# Manufacturer Product Service Bulletin

## Number CW03-01

**Subject:** Capewell Supplied Pins and Ripcords

Broken Ripcord Pin

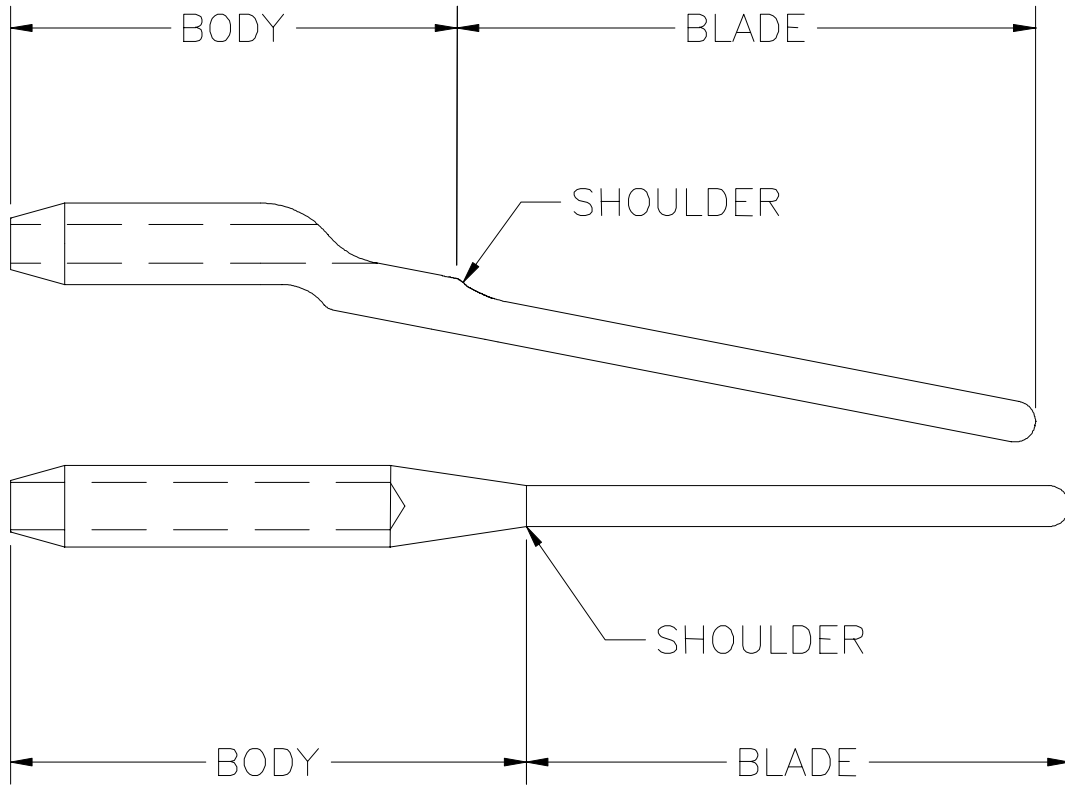
Capewell Components LLC has received (3) reports from (3) customers of (4) ripcord pins that broke. All (4) pins were reported to have broken under very low force. All (4) pins are reported to have broken on the blade section of the pin, approximately 1/8" (3 mm) from the shoulder of the pin. A broken pin is pictured below.

Affected Ripcord Pins are: MS70107 (angled), PS70107 (angled), 61C4304 (angled); 55A6480 (terminal)

**WARNING: A DEFECTIVE PIN COULD CAUSE A PARACHUTE SYSTEM TO MALFUNCTION**

**FIGURE 1**

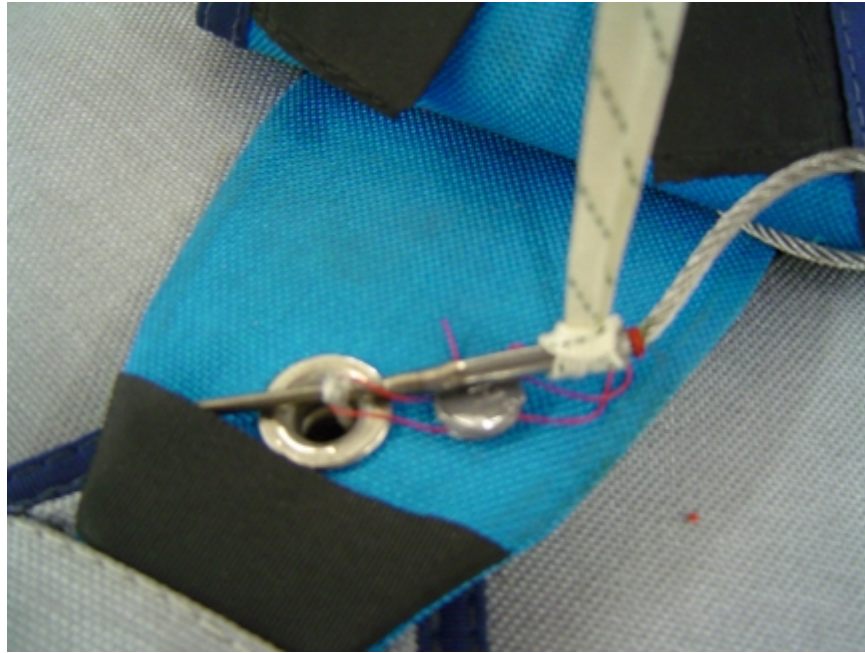
3. Take the suspension line and tie the two ends together with an overhand knot forming a loop.
4. Route the loop around the body of the pin to form a lark's head knot as close to the cable entrance end of the pin body as possible (Fig. 1).

5. Secure the other end of the loop to the spring scale.
6. Apply a load of 15 lbs. (6.8kg) straight up and 90 degrees to the axis of the pin for a period of 3 seconds and then release the load (Fig. 2). Inspect the pin for any deformation or bend. If the pin is straight, continue with step 7 below. If the pin is not straight, as visible without magnification, remove the pin/ripcord from service immediately.

**FIGURE 3**  
All dimension in inches

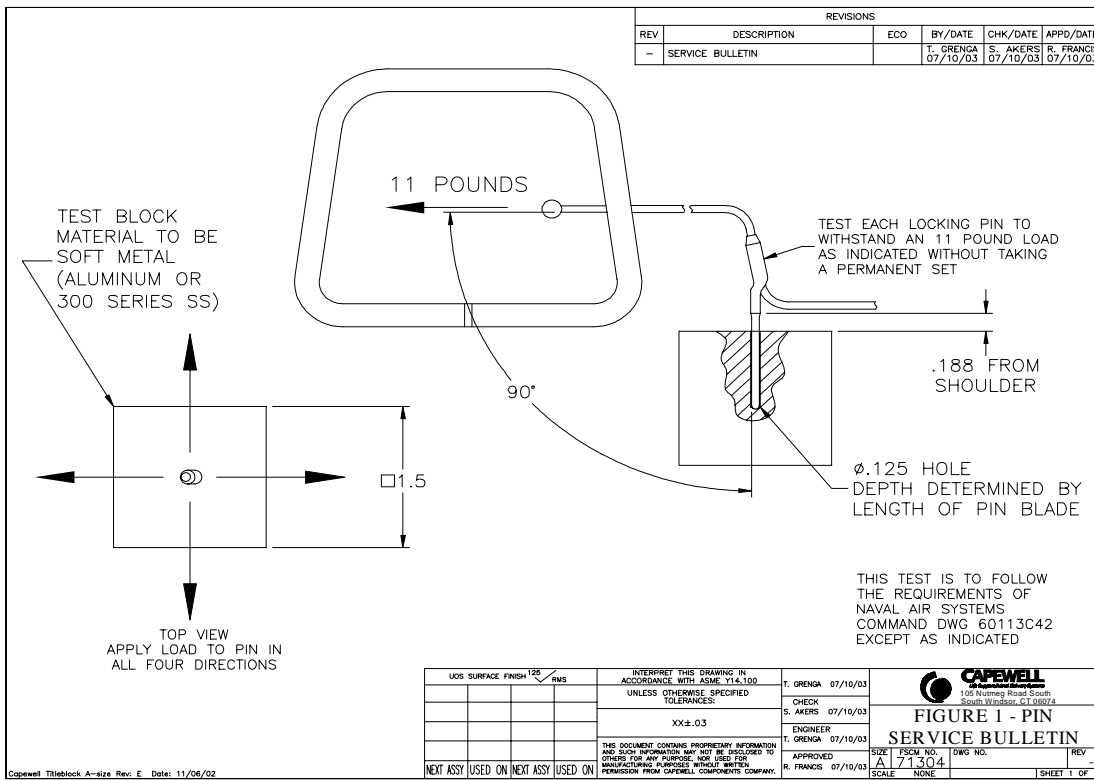
1. Place pin in test block per Figure 3 (below). NOTE: The pin block hole may be VERTICAL or HORIZONTAL
2. Apply 11 lb. force 90 degrees perpendicular to the pin blade.

3. Remove pin from block and inspect:
  - For straightness: Pins in excess of .005 (.12 mm) deformation along the blade of the pin should be removed from service.
